Nythe Road Solar Farm, Ashcott, Somerset TA7 9BG

Landscape Objection Statement

on behalf of Save Our Somerset Levels and CPRE Somerset

2023/1892/FUL– Planning application for ‘Proposed ground mounted solar photovoltaic park, underground cable route and ancillary development. | Land At 342774 135299 Nythe Road, Walton, Street, Somerset’

Viewpoint 9 - Pedwell Hill

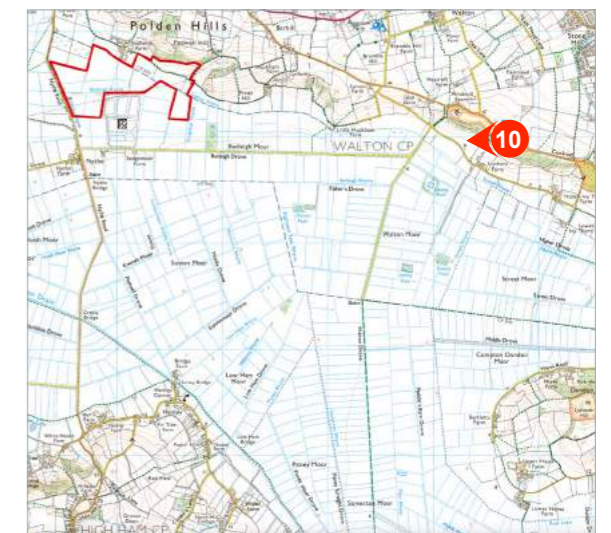
The rural view descending Pedwell Hill on public footpath BW1/45. A view omitted from the submitted LVIA. Proposed development of solar panels, ancillary equipment and the incongruous "Control Room" building (which would sit in the middle of this view) would dominate this rural view and distract from views of the moor and High Ham beyond. This view has been omitted from the submitted LVIA.

Viewpoint 10 - Walton Hill

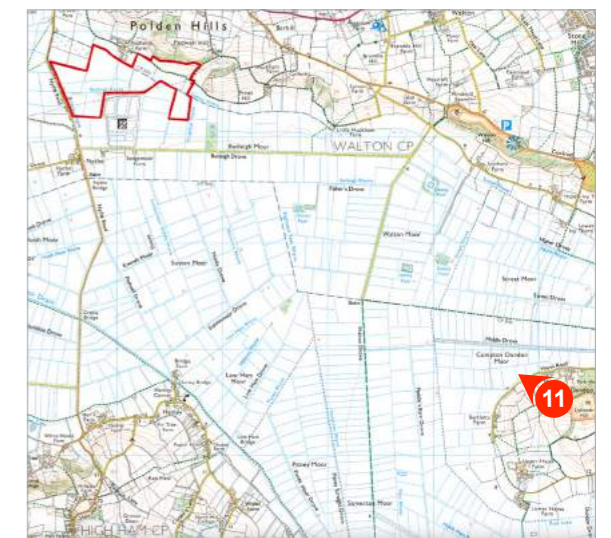
The overtly rural panoramic view from the popular viewpoint within the open access area at Walton Hill. The view over the moor with High Ham in the distance must be one of the best known and finest views in Somerset (even on a bad day). The existing adjacent solar park can be identified amongst vegetation. The proposed development Site would form a smaller part of the overall view but solar panels would be visible even at this distance of approximately 3kms as areas of glassy, grey-white mass similar to the existing solar park and in stark contrast to the surrounding pathwork of soft colours. This photograph identifies the extent of the proposed development Site within the view which is not indicated in the submitted LVIA.
